**LEESBURG BOARD OF ARCHITECTURAL REVIEW
STAFF REPORT**

**WORK SESSION: 5 NOVEMBER 2012
AGENDA ITEM 5a**

BAR Case No. TLHP-2012-0093: Remove free standing ATM and add ATM to side of building facing Market Street.—Additional changes include centering the ATM in the window space so it no longer cuts into the block wall and fits completely within one window instead of cutting across two windows.

Reviewer: Kim K. Del Rance, LEED AP
Address: **1 Catoctin Circle NE**
Zoning: B-2, H-2 Overlay District
Applicant: Paul H. Faulkenbury, Samaha Assoc
Owner: Geo. H. Rucker Realty Corp.

POSSIBLE ATM LOCATIONS

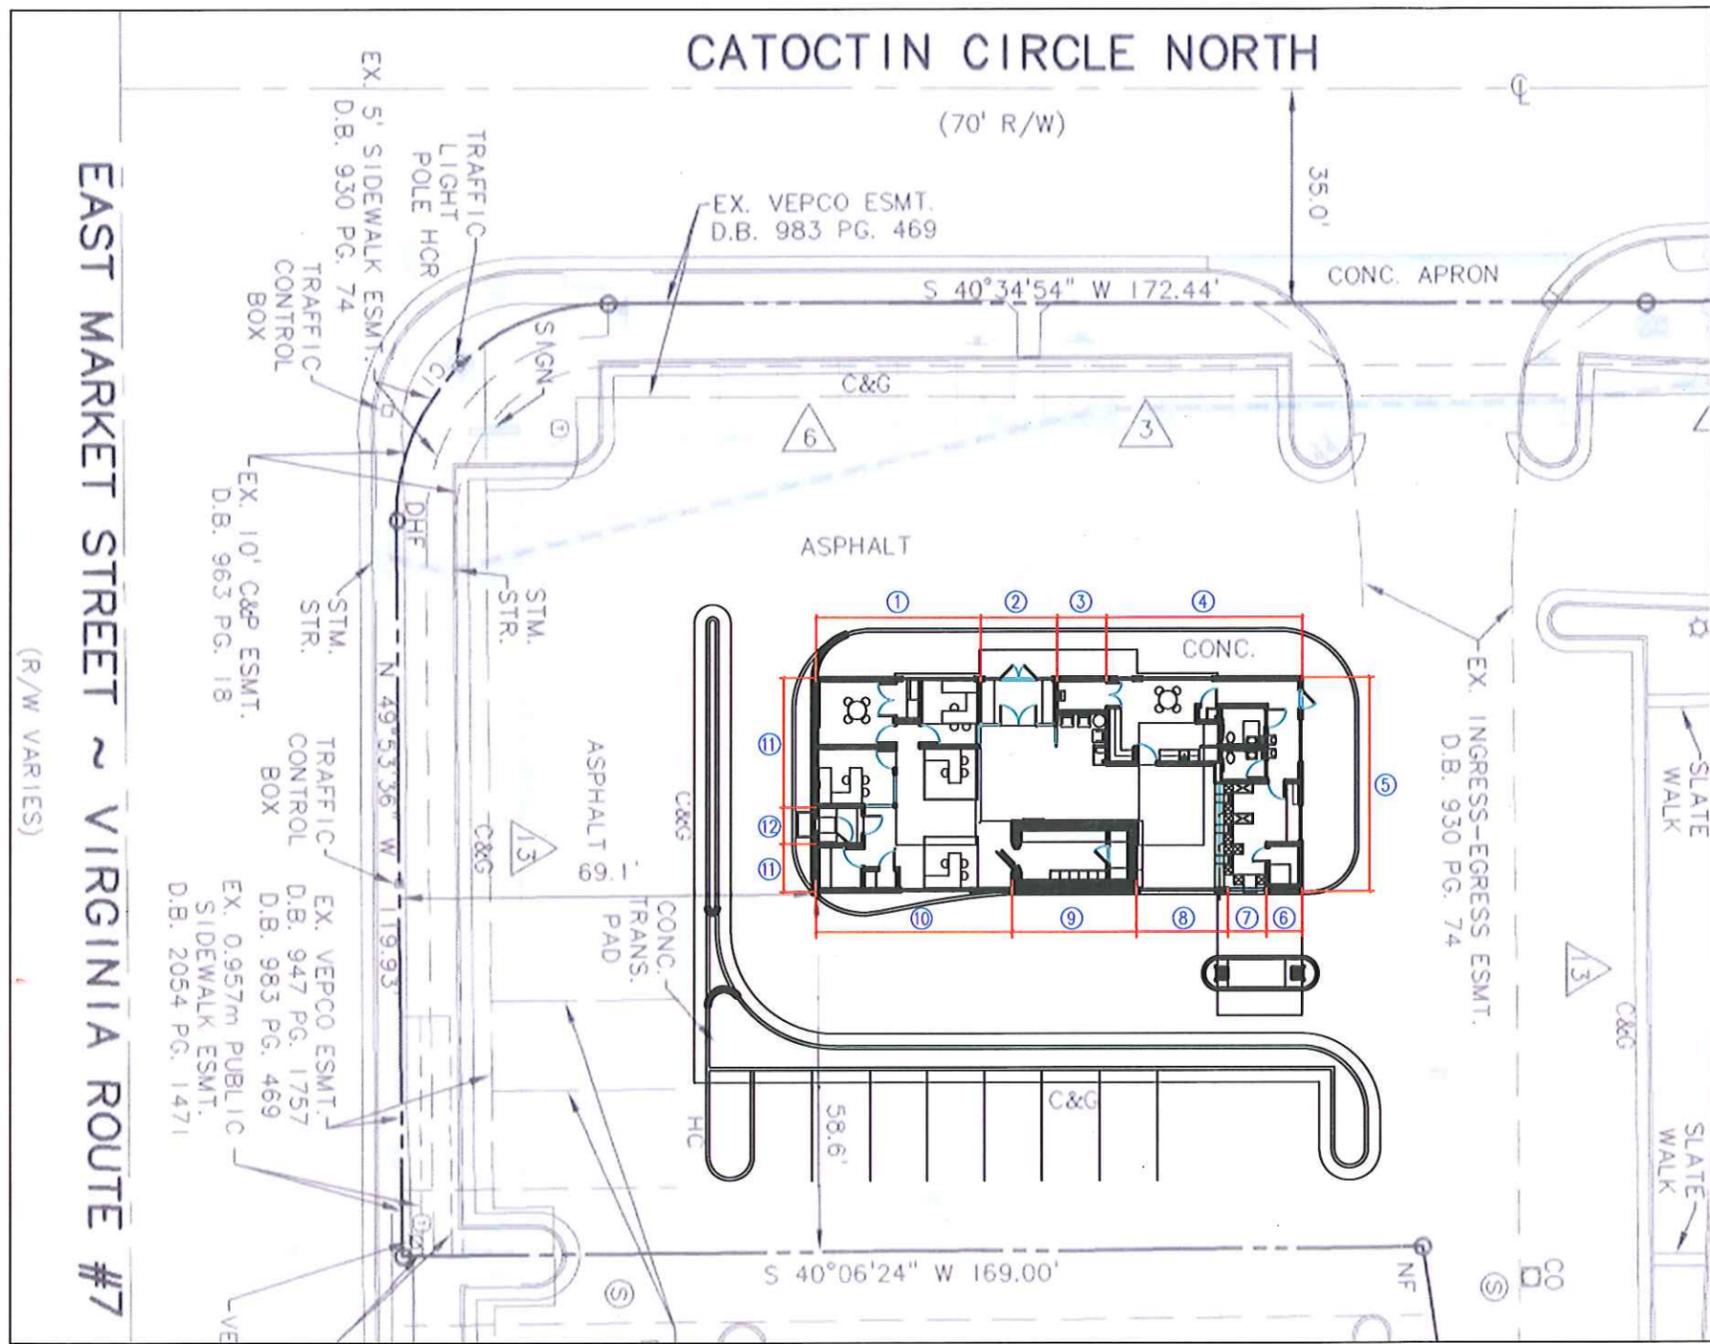
The adjustments to the placement of the ATM in response to the board's previous comments about the awkwardness of the placement is an improvement to the façade, however, the board's overall concern about placing the ATM on the south side facing Market Street at a prominent corner with Catoctin Circle has not been addressed with this solution.

While the guidelines do not specifically address ATMs, the board found that the placement of the ATM on the south side of the building fronting Market Street at the prominent corner of Catoctin Circle was not discreet.

According to the additional drawings submitted by the applicant since the last meeting, the only possible alternative is to place the ATM on the east side in the first lane which would require the installation of equipment to make the second (outside) lane useable for the teller. The applicant has stated this is not preferred by their client due to additional costs and the rearranging of interior spaces resulting in a significant loss of lobby space.

- The board finds the placement of the ATM on the Market Street façade is not discreet and the ATM placement there is obtrusive and damaging to the H-2 Corridor at this prominent location
- The screening should be improved to sufficiently screen the resulting stacked cars

- The ATM will be placed on the east side of the building instead of the south side facing Market Street. The second lane may be reused as a teller lane so as not to reduce the amount of customers that bank my serve on the exterior to accommodate their desire for more security of the ATM.
- the plantings in the existing planting bed along Market Street from the intersection of Catoctin and Market Street east to the second tree should be improved by reducing the spacing to a minimum one foot between shrub edges and increasing the height to a minimum of thirty inches (30")
